Model: MET-C2.1cde	Date: 10-Feb-17	No.: RD0AF001f
--------------------	-----------------	----------------

Subject: New model release information: MP C3004ex/3504ex/4504ex/5504ex/6004ex, MP C2004ex/2504ex		Prepared by: A.Shigeta	
From: 1st Tech Service Sect., MFP/P Tech Service Dept.			
Classification:	<input type="checkbox"/> Troubleshooting <input type="checkbox"/> Mechanical <input type="checkbox"/> Paper path <input type="checkbox"/> Product Safety	<input checked="" type="checkbox"/> Part information <input type="checkbox"/> Electrical <input type="checkbox"/> Transmit/receive <input type="checkbox"/> Other ()	<input type="checkbox"/> Action required <input checked="" type="checkbox"/> Service manual revision <input type="checkbox"/> Retrofit information <input type="checkbox"/> Tier 2 <input type="checkbox"/> Tier 0.5

With the release of the new model for successor of MP C3004/3504/4504/5504/6004 and MP C2004/2504, this RTB was released to announce differences between the predecessor models and the new models.

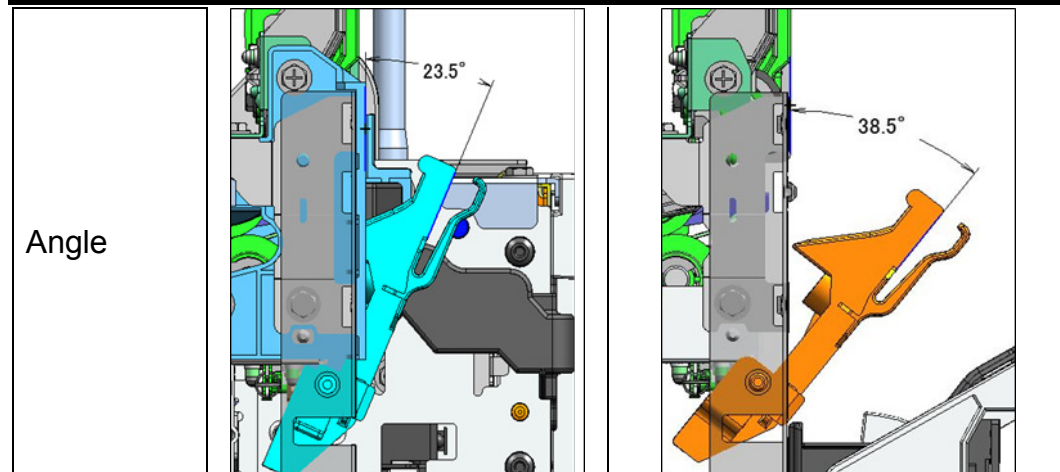
Change: The shape of the guide plate was changed.

1. Release the hook and remove the guide plate.

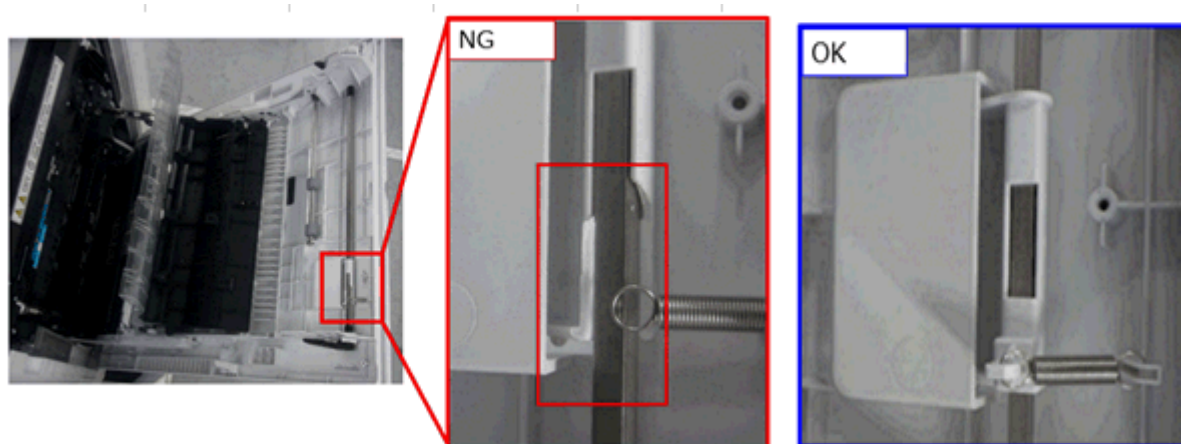
Lubricant contacts the shaft for the grip of the duplex unit, causing a chemical crack. As a result, the hook for the grip breaks and the spring detaches.

Replace the duplex unit grip.

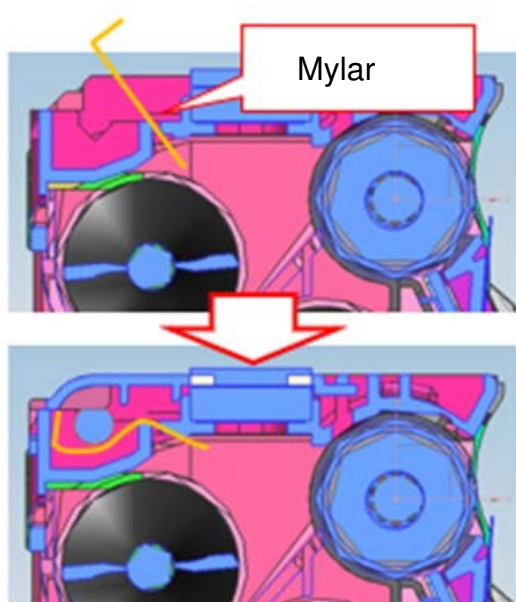
The following sheet was added to the development unit to secure the proper gap between the upper cover and development roller.

P/N	Description	Q'ty
M0AJ3138	SHEET:PROTECT:COVER:DEVELOPMENT	1-1

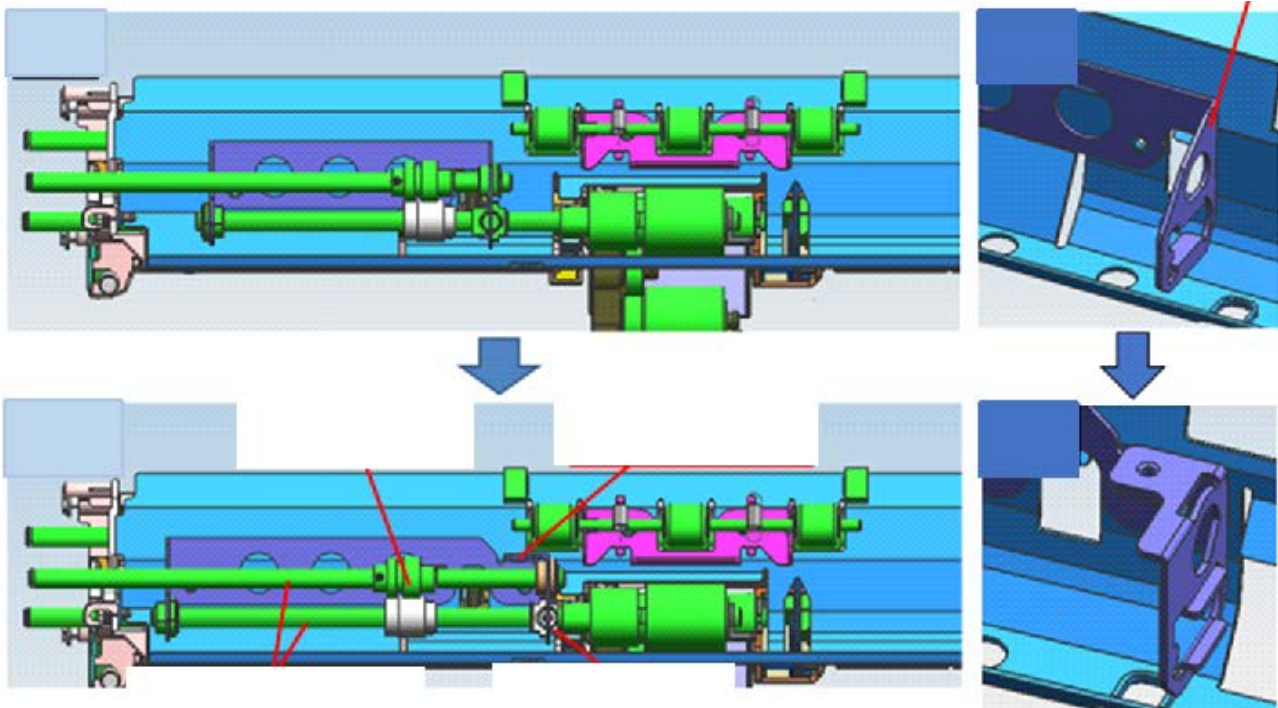
Change 3: The shape of the brackets and bearings, length of the roller shaft, and the gear position has changed. Also e-rings added.

Old P/N <Group B>	New P/N	Description	Int	Q'ty	Note
08050104	08050104	RETAINING RINGS-E:SILENCER:DIA4	-	2->3	C
D1494770	D0BQ2608	SHAFT:SEPARATOR:DRIVEN:ASS'Y	X/X	1	C
M0BW2615	D0BQ2615	GUIDE PLATE:SEPARATOR:ASS'Y	X/X	1	C
D1492619	D0BQ2619	SHAFT:SEPARATOR:DRIVE:ASS'Y	X/X	1	C
D2412653	D0BQ2653	COIL SPRING:PRESSURE:SEPARATOR	X/X	1	C

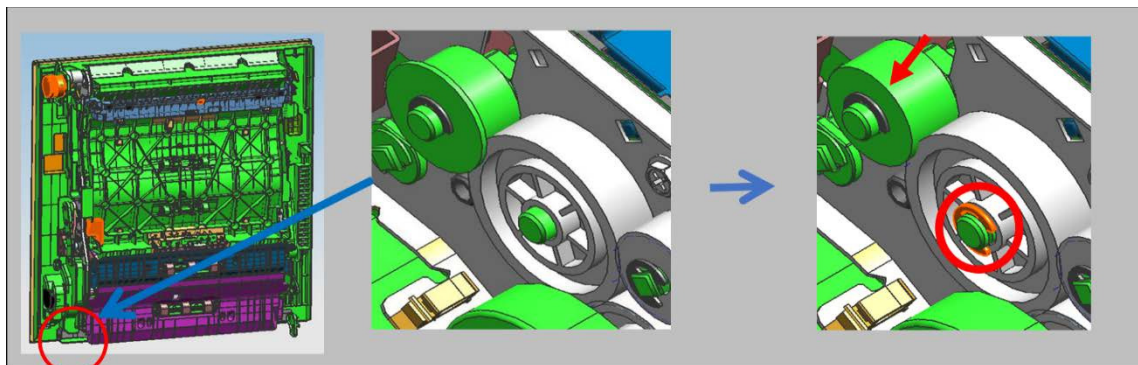
Change 4: There are no protruding parts to hold the gear. An e-ring added to stop the gear in position, and a groove added to the shaft for the e-ring.

Old P/N <Group B>	New P/N	Description	Int	Q'ty	Note
07200040E	07200040E	RETAINING RING - M4	-	3->4	D
D2414631	D0BQ4631	SIDE PLATE:REAR:DUPLEX:PEEN	X/X	1	D
D2414644	D0BQ4644	GEAR:MECHANICAL ROLLER CLUTCH	X/X	1	D

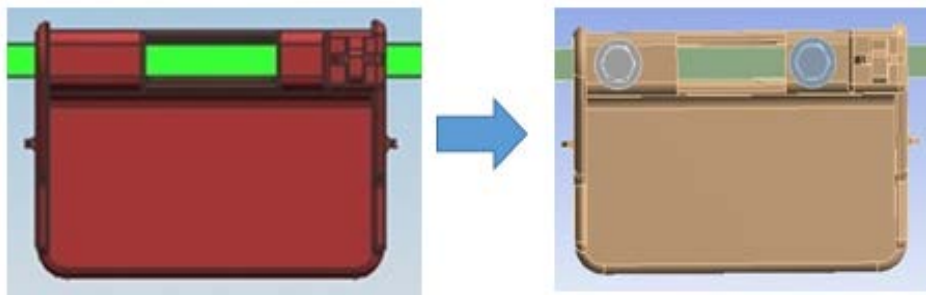
Change 5: The grip of duplex unit has been changed from press fit to screw type.

Old P/N <Group A/B/D>	New P/N	Description	Int	Q'ty	Note
-	03603006N	SCREW - M3X6	-	0->2	E
D1754654	D0BQ4654	SHAFT:LEVER:LOCK	X/X	1	E
D1494655	D2894655	GRIP:DUPLEX UNIT	X/X	1	E
